AMENDED DECISION

Proposal Name: Dodd Residence

Proposal Description: The applicant requests approval of Critical Areas Land Use Permit with a Critical Areas Report in order to construct a single-family residence with a reduced stream buffer.

File Number: 08 129496-LO

The attached plan (**Sheet W3.0**) reflects the changes noted above and the balance of the mitigation plan for the critical areas permit. Based upon our discussions earlier this week, the following changes were made to the mitigation plan:

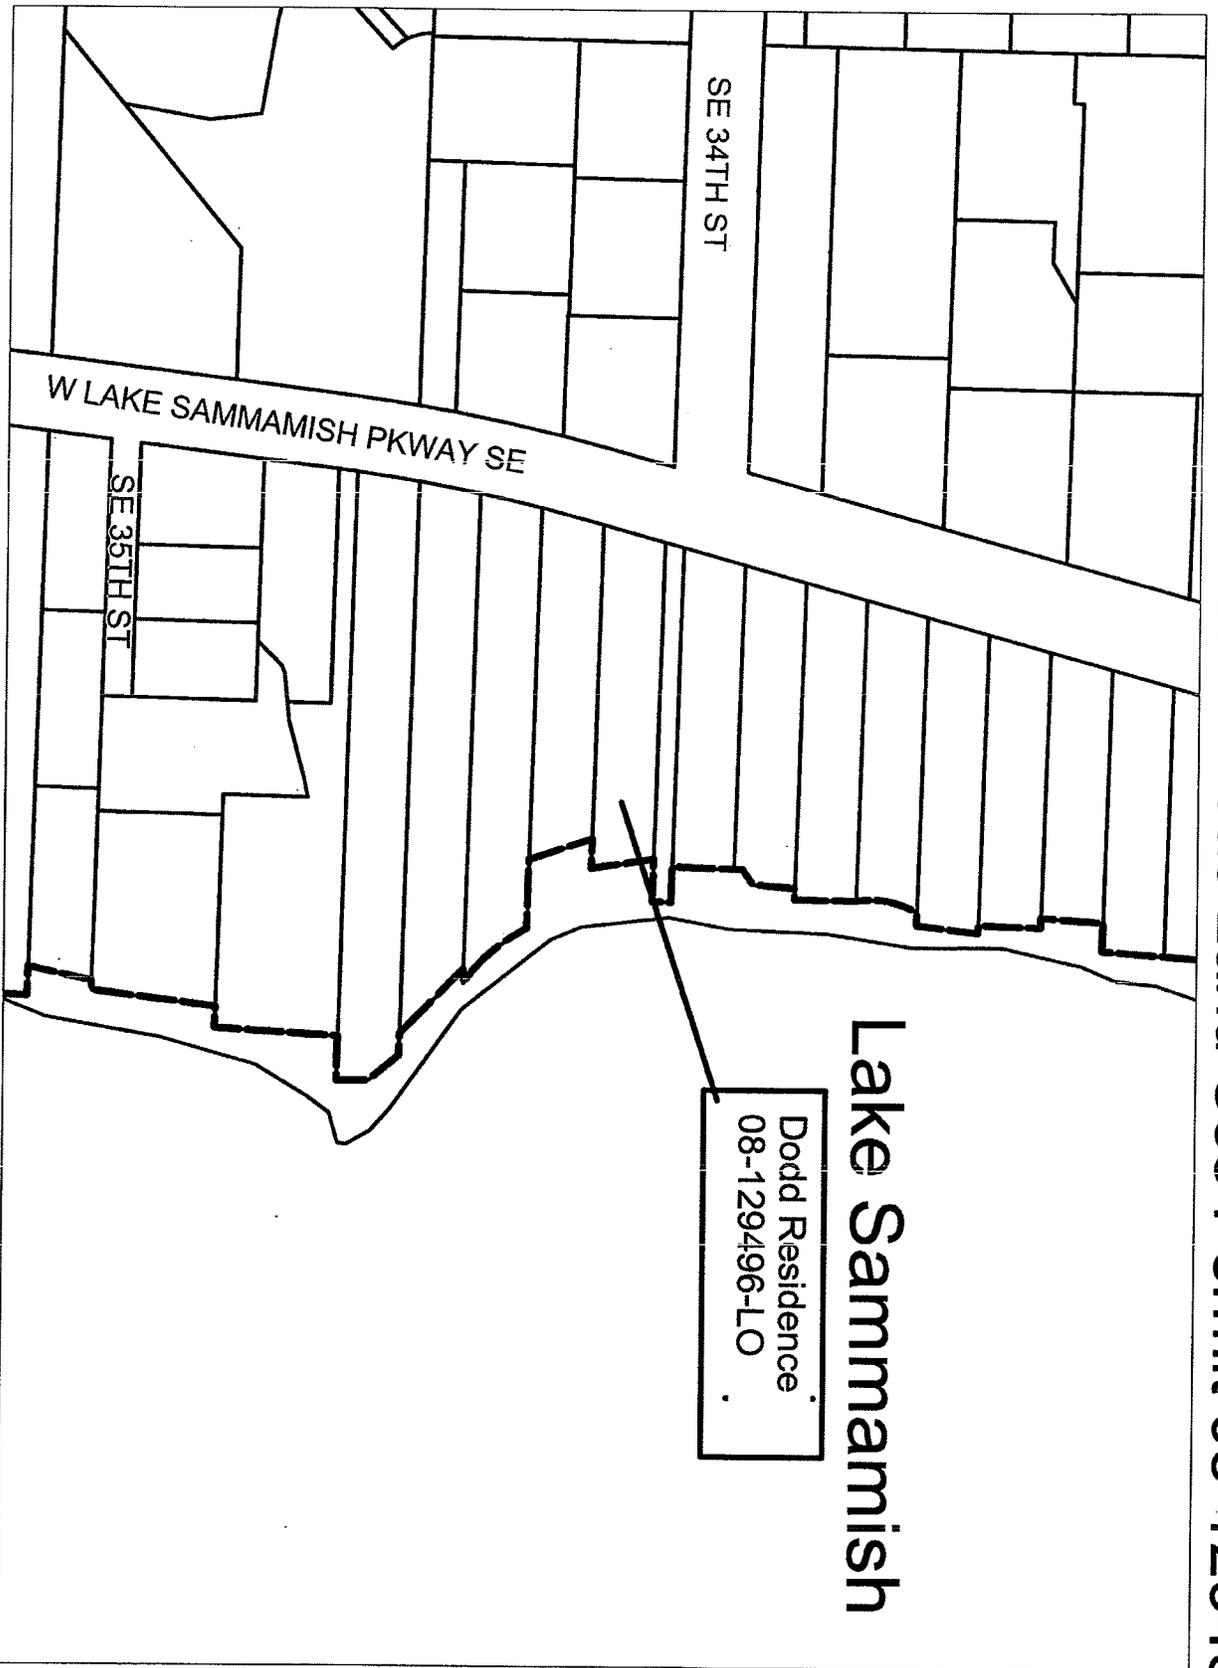
1. The bio-swale was reduced from 3-feet wide to 2-feet wide and was lengthened to begin at the far western corner of the house.
2. The emergent plants originally intended for the bio-swale were changed to a seed mix adaptable to both wet and dry conditions that could also be mowed to allow access around the south side of the house as recommended by Michael Paine.

3. The shrub species to be planted adjacent to the bio-swale were changed to reflect species that would not shade the bio-swale and that would more appropriately fit into the reduced area on the south side of the house.

4. We added two new areas of native plantings to off-set the reduced planted area on the south side of the house. The first area is in front of the deck which provides an additional 121 sf, and the second area is along the rockery on the north side of the house which provides 104 sf. Both of these areas are planted with native shrubs and groundcovers thereby providing a larger native buffer area for the stream (an additional 225 sf).

5. We substantially increased the densities of buffer plantings in the approved stream buffer to provide a jump start to the ecological lift of the buffer over existing conditions.

6. We added the native plants on both the north and south side of the existing patio to satisfy the condition of the previously approved critical area permit.
